Bicycling and On-Street Parallel Parking

with Critiques of 2 Related Documents

Wayne Pein wpein@nc.rr.com

Appendix A. Critique of *An Evaluation of Bike Lanes Adjacent to Motor Vehicle Parking*.

Figure 4. Hollywood Blvd.

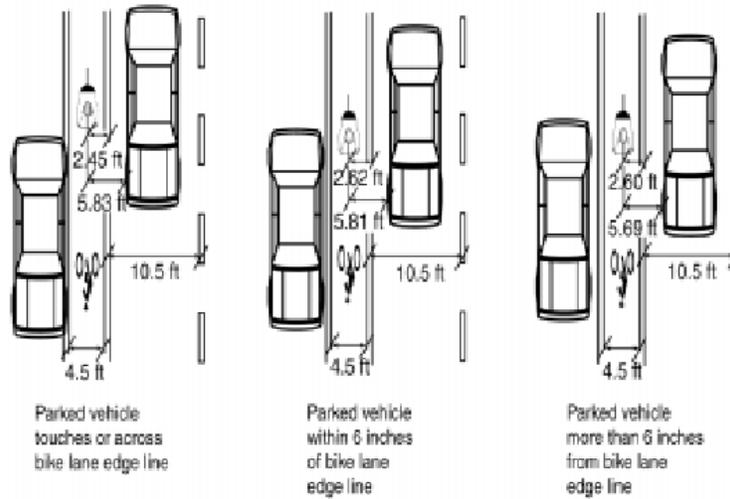
Figure 4 shows that the parking lane is quite narrow at approximately 6-7', not much wider than the parked vehicles or the 5' BL. A1A is similar. Apparent too is that most of the BL is within the so-called “Door Zone” of the parked vehicles since a typical door extends 3-3.5'. Thus, since bicyclists typically position themselves in the center of the BL (also confirmed by the study), they are at risk of being struck/striking a suddenly opening door.

Figure 5. Spacing distances.

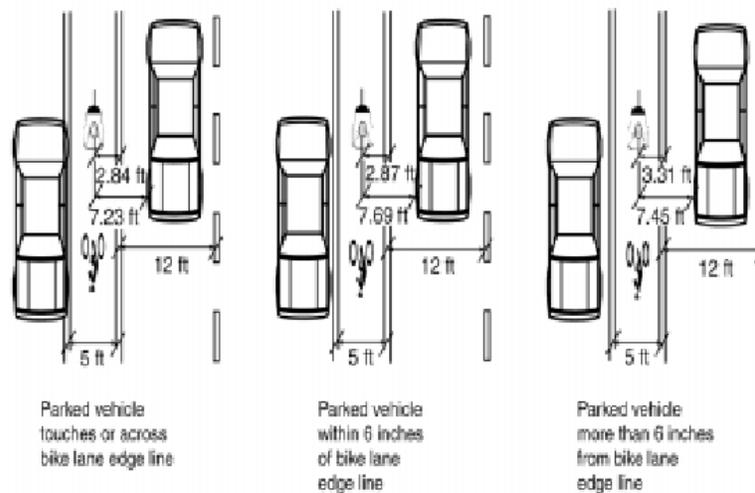
The actual spacing distances are shown below in Figure 5. The BLs are 4.5' wide (inside to inside) at A1A and 5' at Hollywood Blvd, and the adjacent lane widths are 10.5' and 12' respectively. Parking lane widths are not given. As can be seen in Figure 5, a condition “Parked vehicle touches or across bike lane edge line” occurred. The report does not specify the extent of this encroachment on the BL, nor does it give the distribution of parked vehicles or bicyclists riding under the other two parking distance conditions, “Parked vehicle within 6 inches of bike lane edge line,” and “Parked vehicle more than 6 inches from bike lane edge line.”

Figure 6. A drawing from the Guide, modified by the removal a Bike Lane stripe.

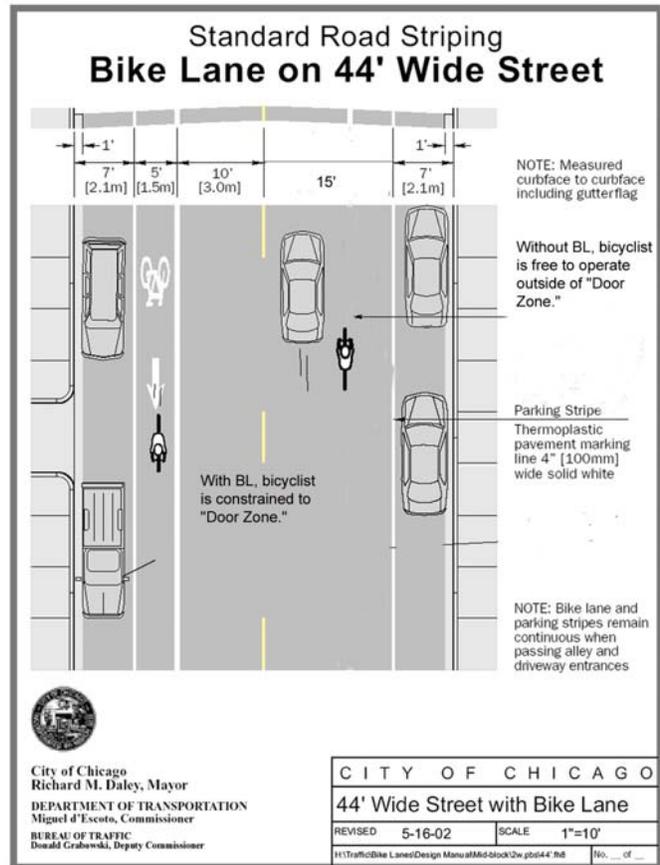
Figure 6 shows a typical drawing from the Guide. I have modified the drawing by removing a BL stripe and adding the commentaries “Without BL, bicyclist is free to operate outside of “Door Zone,” and “With BL, bicyclist is constrained to ‘Door Zone.’”

Also in Figure 6, the parking lanes are 7' wide, just slightly wider than a typical passenger vehicle. Thus, an open door must extend into the BL, as is depicted.

The City of Chicago Department of Transportation created the drawings. Surely the attendant engineers realized that the BLs do not afford sufficient lateral clearance to the parked vehicles, and that a potentially suddenly opening door extends into the BL, creating an obstruction and hazard in the traveled way of bicyclists. The reviewers at the Pedestrian and Bicyclist Information Center, the Association of Pedestrian and Bicycle Professionals, and the Chicagoland Bicycle Federation should also have realized the inherent hazard the designs in the Guide create.
